**ASSAM POWER GENERATION CORPORATION LIMITED**

**Corrigendum-1**

**E-Tender Notice No. APGCL/CGM(NRE)/2023-24/KLM-II HPP/26/03 dtd 16.12.2023**

**Name of work: Geo-Technical Investigation through exploratory drilling and Geophysical Survey (ERT/SRT) at various project locations of 24 MW Karbi Langpi Middle-II Hydro Power Project, West Karbi Anglong, Assam**

**PROPOSED INVESTIGATION PLAN**  
SCALE 1:4000

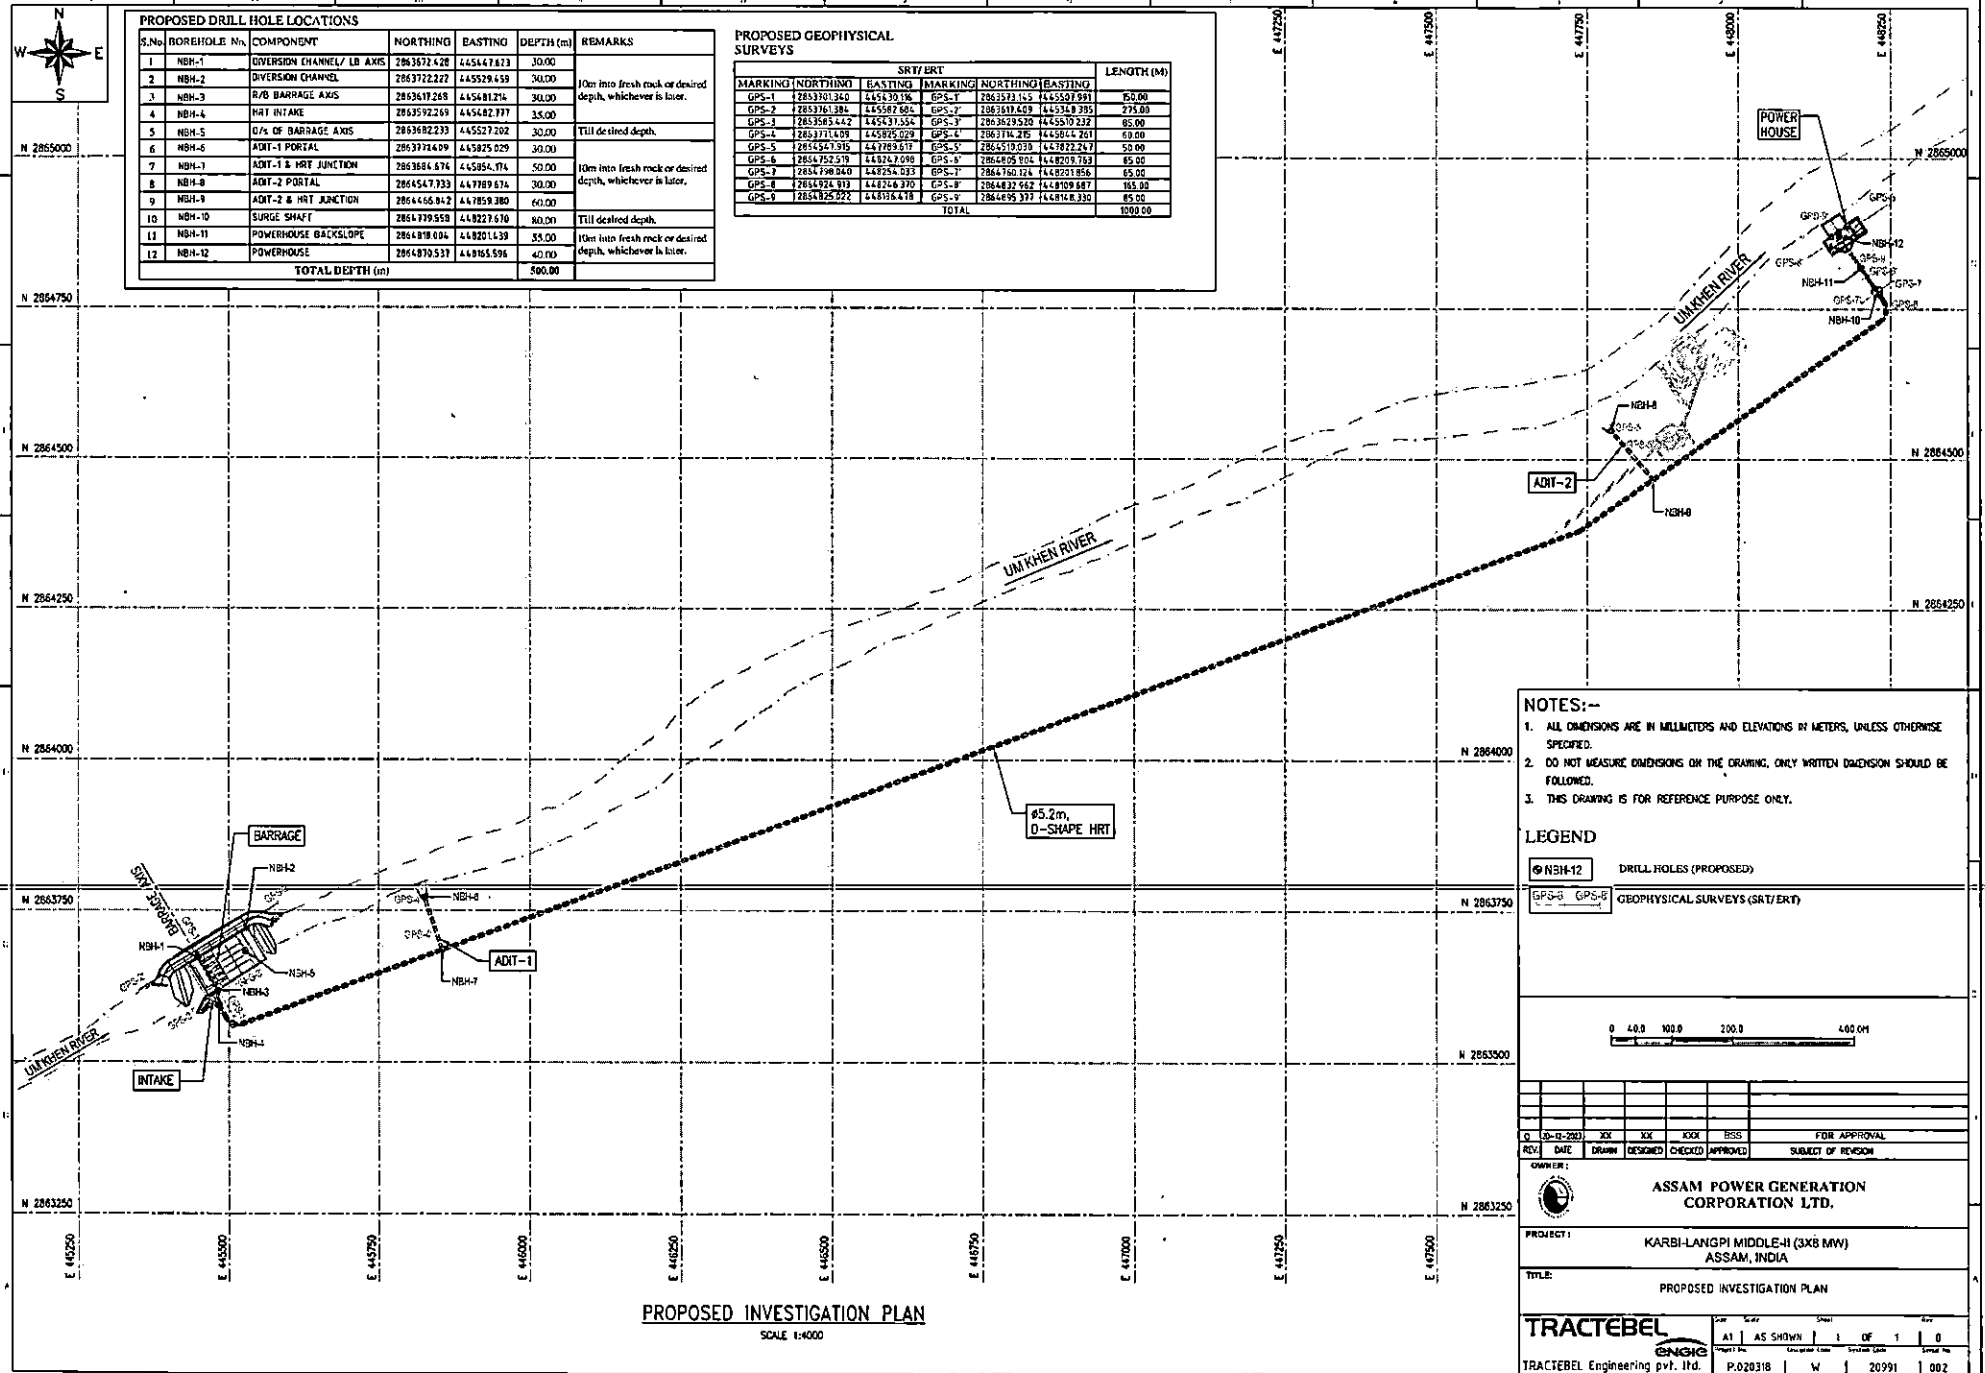
B. Site Layout Plan (for Bid purpose) has been modified with Drill Hole and Geophysical Survey Co-ordinates

PROPOSED DRILL HOLE LOCATIONS						
S.No	BOREHOLE No.	COMPONENT	NORTHING	EASTING	DEPTH (m)	REMARKS
1	NBH-1	DIVERSION CHANNEL/ LB AXIS	2863672.428	445447.613	30.00	
2	NBH-2	DIVERSION CHANNEL	2863722.227	445529.459	30.00	10m into fresh rock or desired depth, whichever is later.
3	NBH-3	R/B BARRAGE AXIS	2863647.268	445618.214	30.00	
4	NBH-4	HRT INTAKE	2863592.269	445482.777	35.00	
5	NBH-5	O/Q OF BARRAGE AXIS	2863682.233	445527.202	30.00	Till desired depth.
6	NBH-6	ADT-1 PORTAL	2863724.099	445825.029	30.00	
7	NBH-7	ADT-1 & HRT JUNCTION	2863684.674	445864.374	50.00	10m into fresh rock or desired depth, whichever is later.
8	NBH-8	ADT-2 PORTAL	2864547.733	447789.674	30.00	
9	NBH-9	ADT-2 & HRT JUNCTION	2864466.942	447858.280	60.00	
10	NBH-10	SURGE SHAFT	2864739.959	448227.670	80.00	Till desired depth.
11	NBH-11	POWERHOUSE BACKSLOPE	2864819.084	448207.439	55.00	10m into fresh rock or desired depth, whichever is later.

12	NBH-12	POWERHOUSE	2864870.537	448165.596	40.00	
TOTAL DEPTH (m)					500.00

PROPOSED GEOPHYSICAL SURVEYS						
MARKING		SR/T/ERT		LENGTH (M)		
NORTHING	EASTING	MARKING	NORTHING	EASTING		
GPS-1	2863701.340	445430.136	GPS-1	2863573.155	445507.991	60.00
GPS-2	2863761.384	445587.605	GPS-2	2863617.609	44534.8395	275.00
GPS-3	2863585.442	445431.554	GPS-3	2863629.509	445510.232	85.00
GPS-4	2863711.439	445395.029	GPS-4	2863718.216	445204.261	63.00
GPS-5	2864547.915	447789.617	GPS-5	2864510.039	447822.247	50.00
GPS-6	2864752.519	44824.090	GPS-6	2864805.904	448205.763	85.00
GPS-7	2864798.840	448254.033	GPS-7	2864760.124	448203.856	65.00
GPS-8	2864824.913	448234.370	GPS-8	2864832.582	448109.887	85.00
GPS-9	2864825.722	448194.418	GPS-9	2864695.377	448148.930	65.00
TOTAL						1000.00
